7. If Unit of CA/Agreement, Name and/or No.
NMNM071016X8. Well Name and No.
PLU PIERCE CANYON 20-24-30 USA 1H9. API Well No.
30-015-3969210. Field and Pool or Exploratory Area
WILDCAT; BONE SPRING11. Country or Parish, State
EDDY, NM

CHESAPEAKE IS REQUESTING THE FOLLOWING CHANGE.

Proposal for 3 stage cement job to bring cement to surface in annulus of production casing

**PLU Pierce Canyon 20-24-30 USA 1H
30-015-39692
Chesapeake Agent for BOPCO
January 17, 2012
Conditions of Approval**

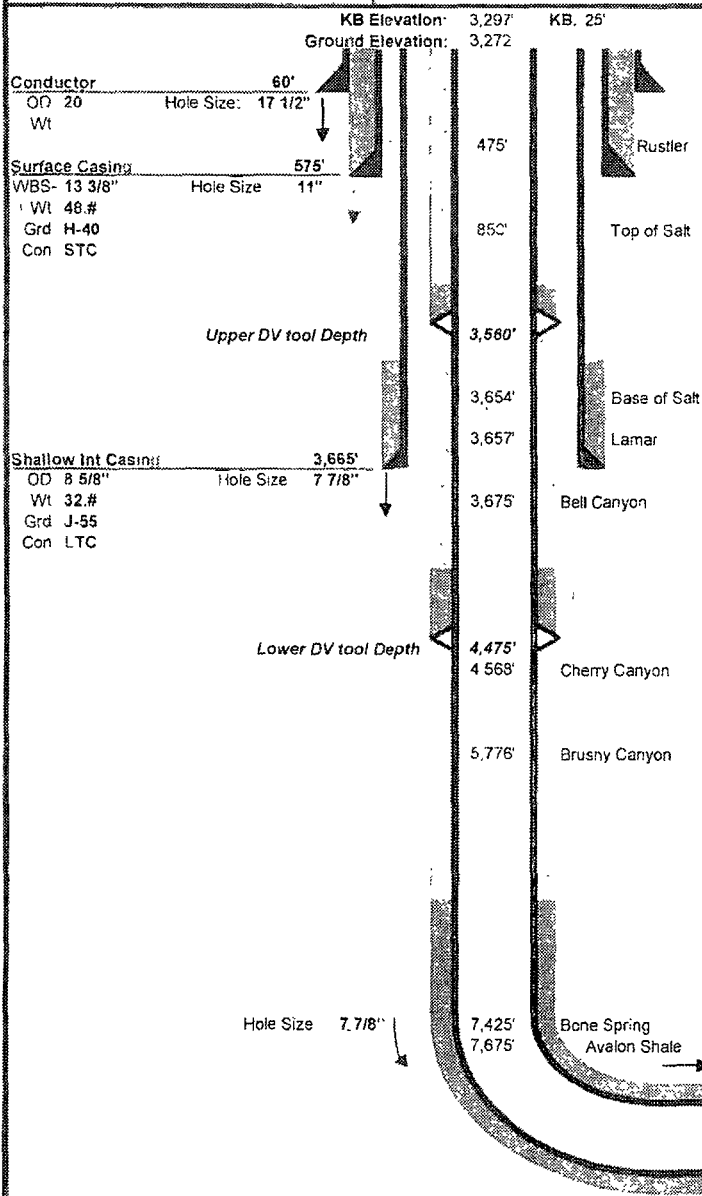
Changing cementing plan for 5-1/2" production casing due to failure to bring cement to surface on 8-5/8" intermediate casing cement job (was topped out afterward). New plan changes from a 2 stage job to a 3 stage job. Please see attached for cement slurry and volume details.

Last week I spoke with you and Ted Morgan on the phone because we had to top out our cement behind on 8-5/8" intermediate casing for the PLU Pierce Canyon 20-24-30 USA 1H. We agreed to bring cement to surface on our production casing to help ensure isolation and protection of water zones. Please see the attached proposal for a 3 stage cement job to bring cement to surface.

This is the same setup we run for every well with the exception the we added another DV tool 100' inside of our 8-5/8" casing. We will use the third stage to make sure we bring cement to surface.

1. The minimum required fill of cement behind the 5-1/2 inch production casing is:

- a. First stage to DV tool - cement to circulate. If cement does not circulate, contact the appropriate BLM office before proceeding with second stage cement job. Operator should have plans as to how they will achieve circulation on the next stage.**
- b. Second stage to DV tool - cement to circulate. The operator's request for variance to set the second DV tool above the intermediate casing shoe is approved. However, if cement does not circulate, the third stage shall not be pumped until the operator confirms the top of cement on the second stage and receives approval from the BLM to pump the third stage.**
- c. Third stage - cement to circulate to surface. If cement does not circulate, operator to contact the appropriate BLM office.**
